CONSTRUCTION SUMMARY				
Red Oaks on Bayview - Trinimont Developments Inc.				
PURCHASER: RUIXIN WANG			JUN 22 2023	TEL:
LOT / PHASE 159 / 1	REG. PLAN # 65M-4737	HOUSE TYPE Birch 2 Elev B

LOT 159 TRINIMONT. - GARAGE MAN DOOR OPTION 2

BIRCH 2
ELEV B.
 LOT 159
 TRINIMONT

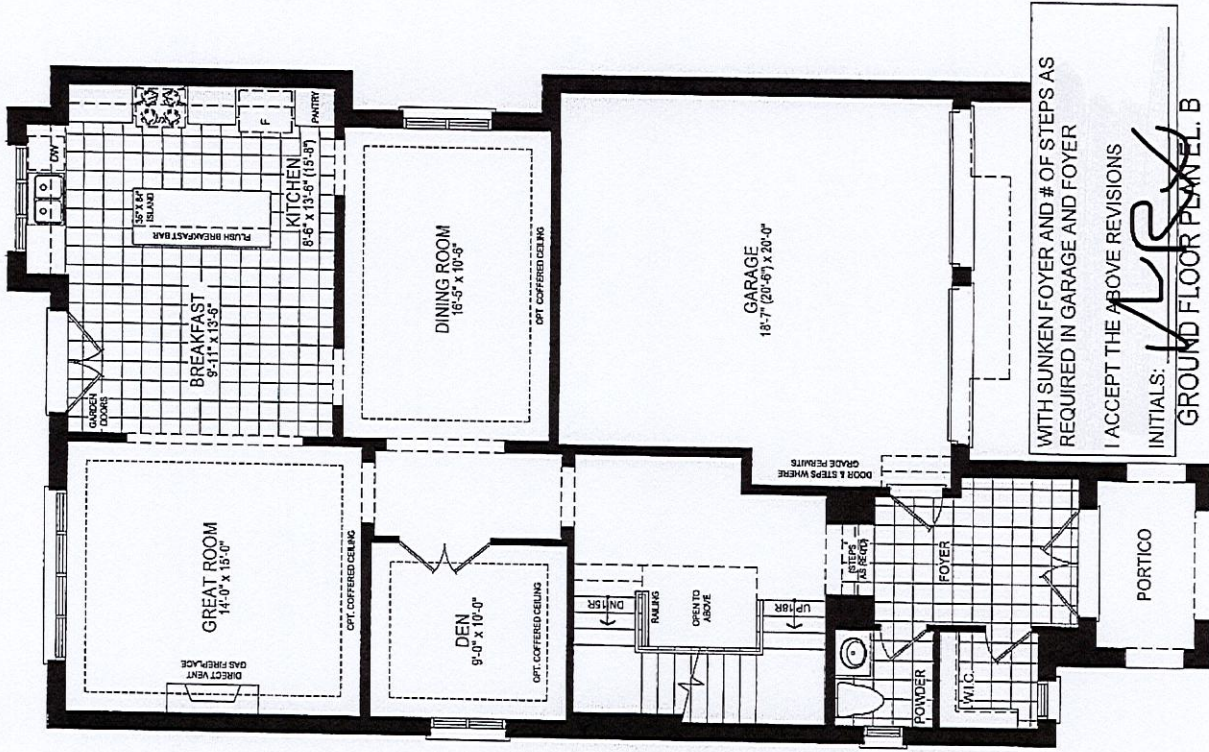
I - PURCHASER HAS ELECTED TO HAVE THE VENDOR CONSTRUCT THE DWELLING UNIT BY INSTALLING THE GARAGE MAN DOOR WITH ACCESS TO THE INTERIOR OF THE DWELLING UNIT IN ACCORDANCE WITH THE PLANS INITIALLED AND ATTACHED TO THIS AMENDMENT. 20Jun23 Note:	
--	--

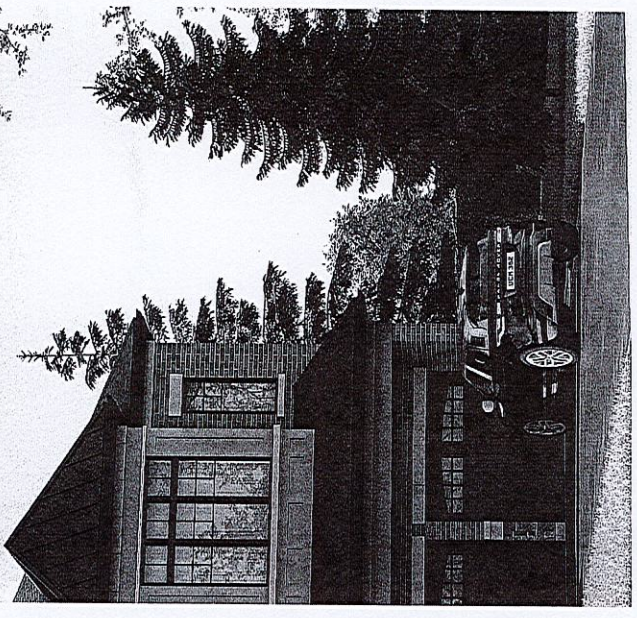
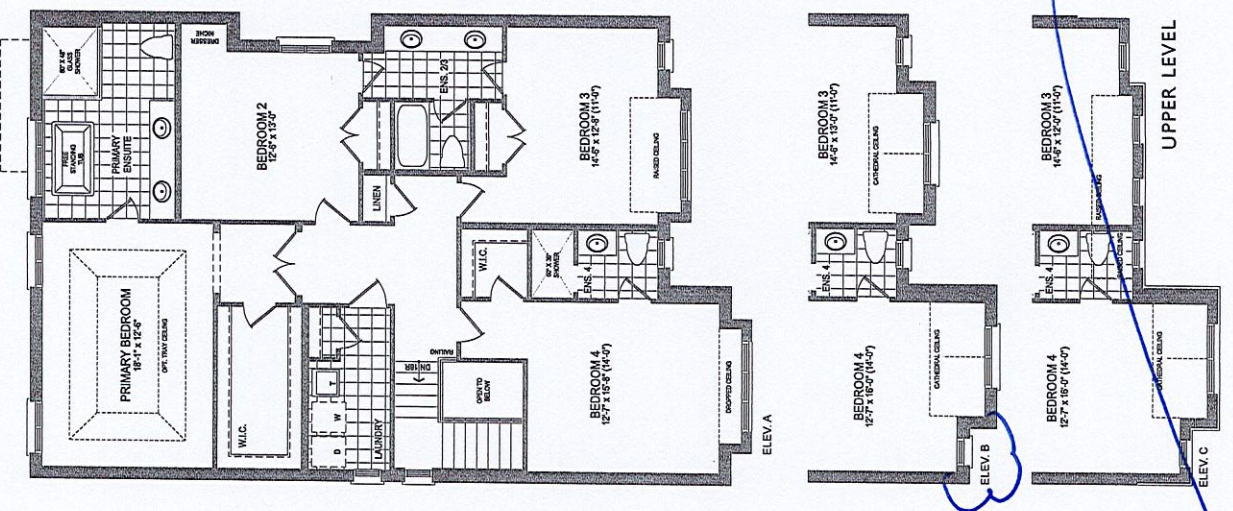
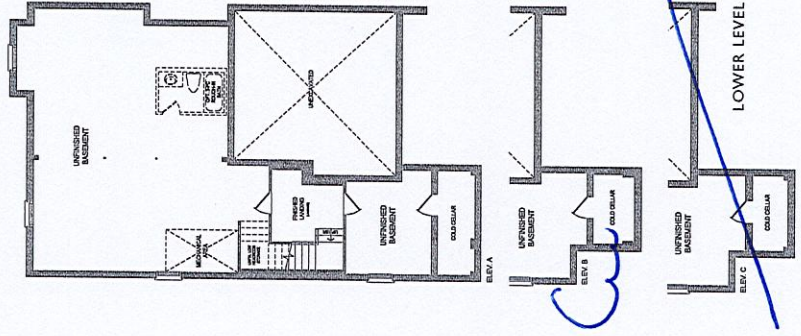
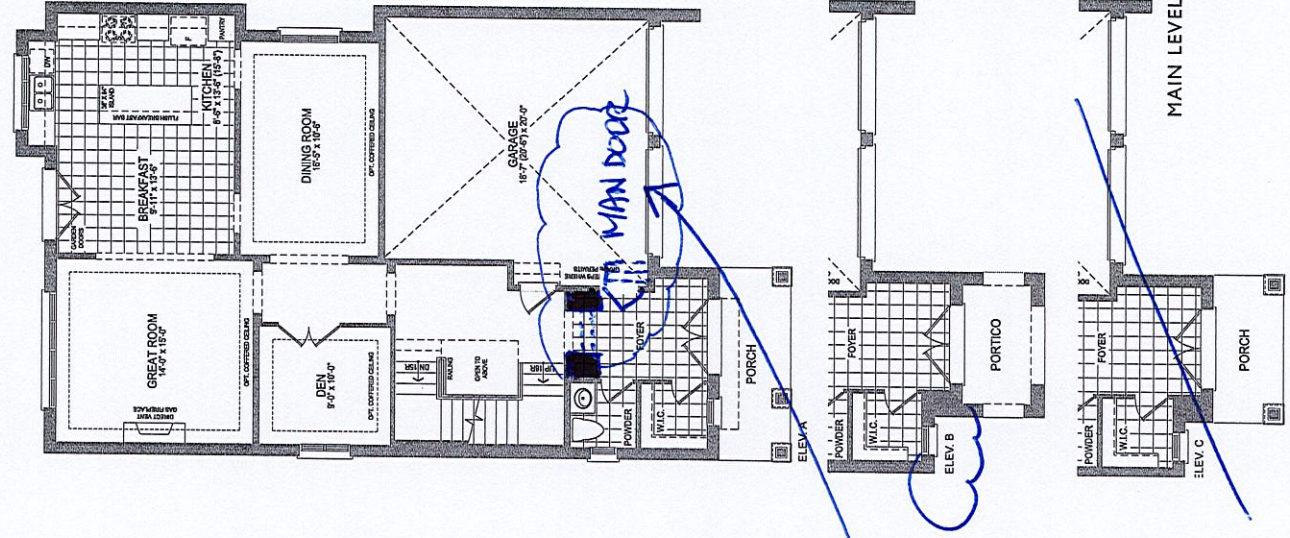
★ SEE REVISED LAYOUT
 -SUNKEN FOYER TO
 ACCOMMODATE GARAGE MAIN DOOR
